Modifications Notices

June 28, 2012
No. PCE-L-1206007

**Tactile Switch B3Jseries
Modification Notice of material change of plunger**

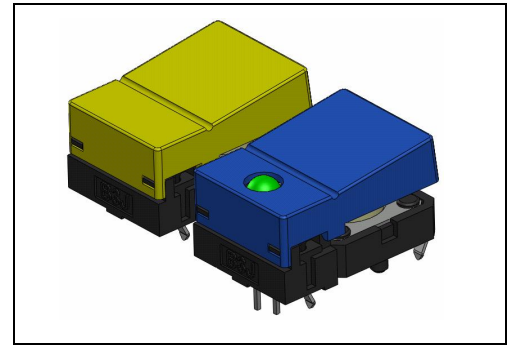
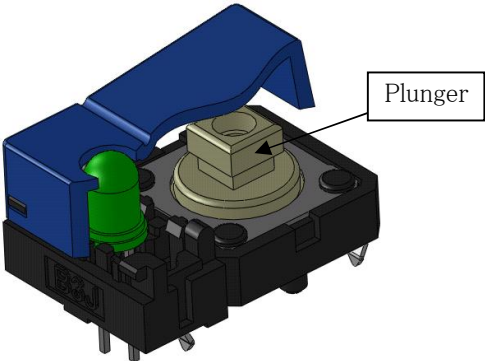
Before the change	After the change
<p>Material change of plunger Plunger material : ABS resin</p> 	<p>Material change of plunger Plunger material : PBT resin</p> <p>No change of the outline drawing and the specification.</p>
